<b>Extreme Engineering</b> 9198-B Ridge Road Newcastle CA, 95658 USA Phone: 916/663-1560 Fax: 916/663-9249 info@extremeengineering.com	Bulletin No:001
		Release Date:04/28/04
		Effective Date:04/28/04
		Supercedes: N/A
		Completion Date:
		Page: 1 of 2
<h1>SERVICE BULLETIN</h1>		
Ride Manufacture: Extreme Engineering	Affected Production Date: All AB-34 and AB-44	
Ride Name: AB-34 and AB-44 auto belays.	Affected Serial Nos.: All	
Model Number: AB-34, AB-44		
<b>Abstract Of Issue:</b> Systems must have the proper amounts of fluid to operate safely. To prevent any issues the following bulletin is being sent. The following details must be checked. Any questions, please refer to on-line manuals @ <a href="http://www.extremeengineering.com">www.extremeengineering.com</a> or contact us at (916) 663-1560. <ul style="list-style-type: none"> <li>• Fluid level of tank</li> <li>• Loose and or missing parts</li> <li>• Cable installation</li> <li>• Cable condition</li> <li>• Recommended mounting methods of belay in the box.</li> </ul>

Fig. A1.2 Service Bulletin

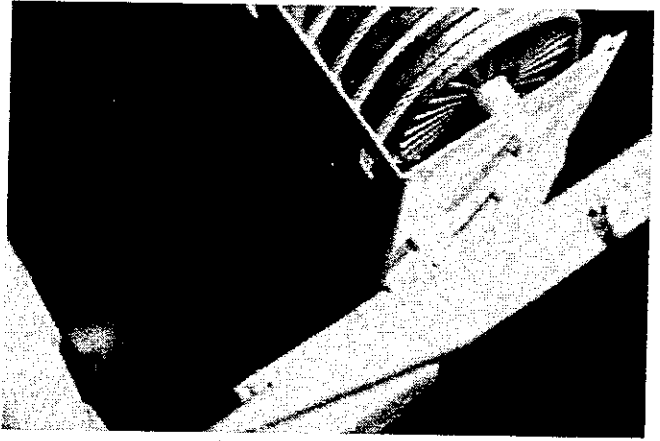
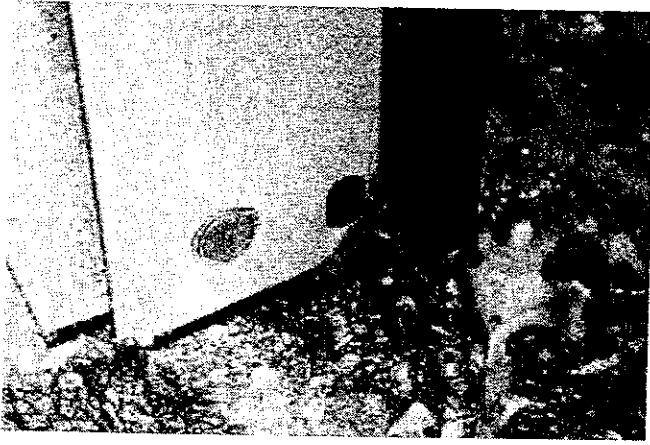
<b>Detail of Issue:</b> Debris/oil on floor, Missing/loose parts, welded not bolted as required, cable installed backwards.

<b>Reason For Release:</b> To ensure that products in service are safe to operate.		
<b>Action To Be Taken:</b> Check fluid levels in all auto belay tanks. All models AB-34 (eight foot long box) must have a minimum of 4 quarts maximum of 6 quarts of Dextron 3/Mercon ATF. Models AB-44 must have minimum of 6 quarts and maximum of 8 quarts. If ever-in doubt of fluid levels, system must be drained and refilled with correct amount of Dextron 3/Mercon ATF fluid. To check proper tank level; Allow cable to fully retract to top of wall. (Attach rope for retrieval) Site-glass type tank, look into site glass with bright flashlight if reddish fluid is visible system level is correct. Non-site glass type, Release all air pressure from tank by removing air valve with removal tool. <b>NEVER</b> remove any fitting or hose from system without first releasing all system pressure. Remove gauge from tank top using a 14mm wrench. Using a clean wire ( 32" long) as a dip stick insert to tank bottom. For proper level 3" to 6" of fluid must be present. Seal and install gauge. System Pressures; AB-34 55 PSI to 65 PSI AB-44 75 PSI to 85 PSI Or as marked/tagged on specific system. All fasteners, snap-rings, clips, lids, caps, hoses must be properly installed and operational. No loose parts/pieces allowed. Any oil or leaks must be investigated and stopped before product can be used. Before pressure is added to system correct oil level must be confirmed. All Auto Belay of this model must adhere to mounting specifications out-lined in manual, <b>DO NOT WELD</b> on housing! Cabels must be in excellent condition and installed correctly.
